## **APPENDIX H**

# **NYSDEC RESPONSES TO COMMENTS AND SUPPORTING DATA**

**This appendix provides a separate response to comments addressing the New York State Department of Environmental Conservation (NYSDEC) comments on the Fresh Kills Park DGEIS. A copy of these written comments is provided in Attachment I. The comments are dated June 20, 2008, but were received August 20, 2008. Provided below is a response to each comment. In addition, this Appendix contains additional supporting data (e.g., text, tables, and graphics) that has been requested by the comments. This additional data has also been summarized in the main body of this FGEIS, where referenced by the comment.**

**Table H-3**  
**Preliminary Project Schedule and Stormwater Permitting Data**

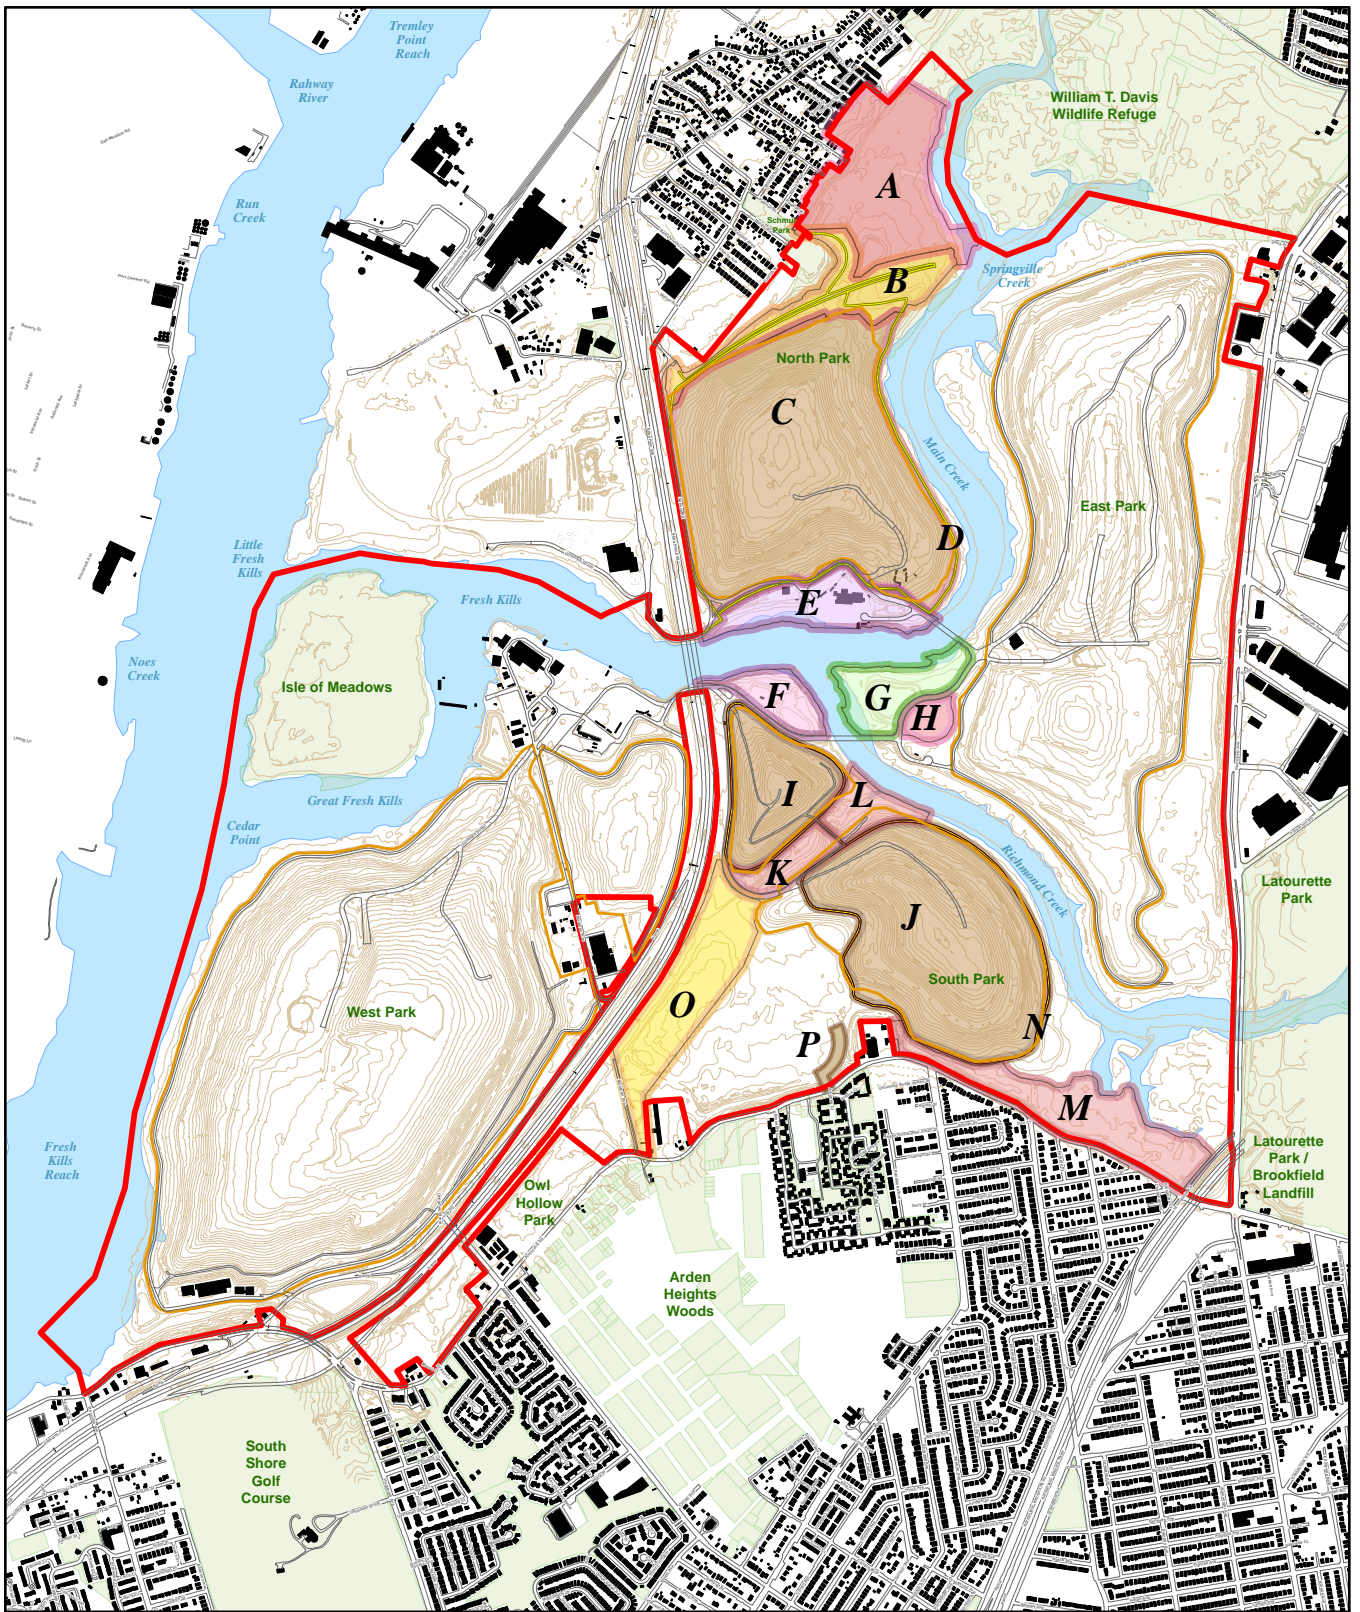
**Comment 7:** SPDES Permitting (Please refer to DGEIS’s Natural Resources, Infrastructure, and Construction Chapter): Based on Part VII, subparagraph K of the SPDES General Permit (GP-0-08-001) for Stormwater Discharges from Construction Activity, it is recommended that stormwater discharges for the Fresh Kills

As stated above, Fresh Kills Park is a multi-year, multi-phase project that over the next 30 years would be comprised of numerous projects with different acreages, land use types and drainage characteristics. Figure H-1 in this FGEIS (Appendix H) presents a preliminary phasing diagram for the proposed project and Table H-3 presents preliminary project phasing providing additional data (as is available at this time) as to areas of land disturbance and proposed coverage, stormwater management, project phase, estimated construction period, and whether the project site is on or off the landfill, and does or does not utilize the existing DSNY Fresh Kills drainage facilities.

As shown in Table H-3, the Fresh Kills Park capital projects would be built over many decades, with a variety of projects, many of which would be small in scale and both on and off the landfill mounds at the site. In addition, the Fresh Kills Park project would reflect the requirements of the proposed stormwater management plan (see FGEIS page 1-74 for a summary of stormwater management principles). Overall, the park projects are not expected to result in negative impacts on drainage or water quality, but by improving final soil and vegetative cover would be expected to result in local water quality benefits.
